UNITED STATES PATENT AND TRADEMARK OFFICE

APPLICATION NO.	FILING DATE	FIRST NAMED INVENTOR	ATTORNEY DOCKET NO.	CONFIRMATION NO.
10/775,934	02/09/2004	Arnd Kausch	71229	3171

Office Action Summary

Figure 2
Prior Art: US 4513452

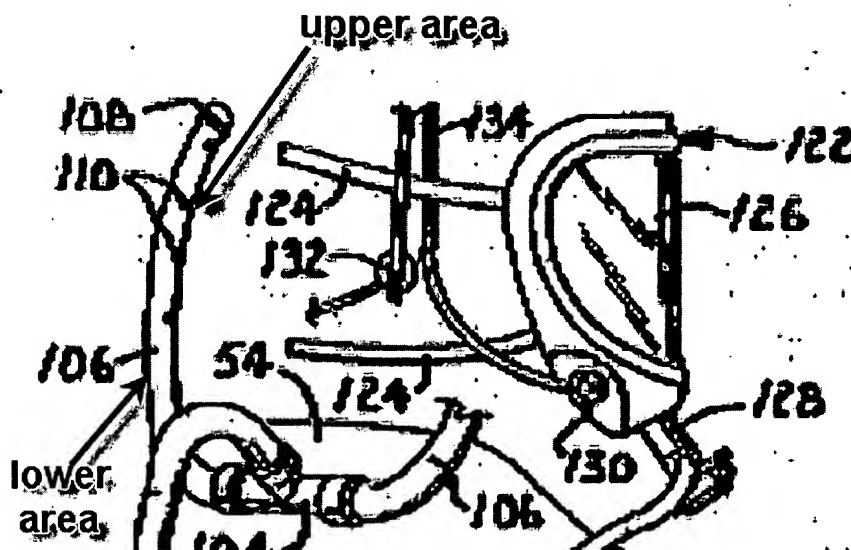
Claims 1, 3-5, 8, 10-12, 15-18, and 21 are rejected under 35 U.S.C. 102(b) as being anticipated by Rankin, Sr. et al. (US 4513452). Rankin, Sr. et al. disclose a device for supplying breathing air in an interior of safety clothing, the device comprises a connection means 70 to a compressed air source 66 for providing breathing air (abstract, lines 5-6) (column 3, lines 66-67). Although Rankin, Sr. et al. disclose the cooling air as being split from the breathing air, this cooling air would continue to read as a compressed air source for providing breathing air. The cooling air still broadly reads as being breathable by a user. Therefore, element 106 does in fact receive breathing air from a connection means 70. Rankin, Sr. et al. continue to disclose a hose system that is connected to said connection means 70 from which breathing air enters said interior of said safety clothing, wherein said hose system further comprises a permeable tube section made porous (apertured tube 106) and receiving the breathing air from the connection means 70 (columns 3, lines 67-68 to column 4, lines 1-18). The definition of permeable is having “pores or openings that permit liquids or gases to pass through” (dictionary.com). Therefore, section 106 with apertures can be defined as being permeable. Rankin, Sr. et al. further disclose the permeable tube section 106 is formed in a horizontally extending semicircle through t-fitting 104 and is placed at level of a neck part of a user of said safety clothing (see Figure 2). The horizontally extending semicircle 106 further comprises a lower area and an upper area wherein said lower area is sealed and said upper area is porous (See Figure 2 below).

still broadly reads as being breathable by a user. Therefore, element 106 does in fact receive breathing air from a connection means 70. In addition, patent 452' teaches a permeable tubular section made porous (apertured tube 106). The definition of permeable is having "pores or openings that permit liquids or gases to pass through" (dictionary.com). Therefore, section 106 with apertures can be defined as being permeable. Tubular section 106 extends horizontally in a semicircle through section 104 as shown in Figure 2.
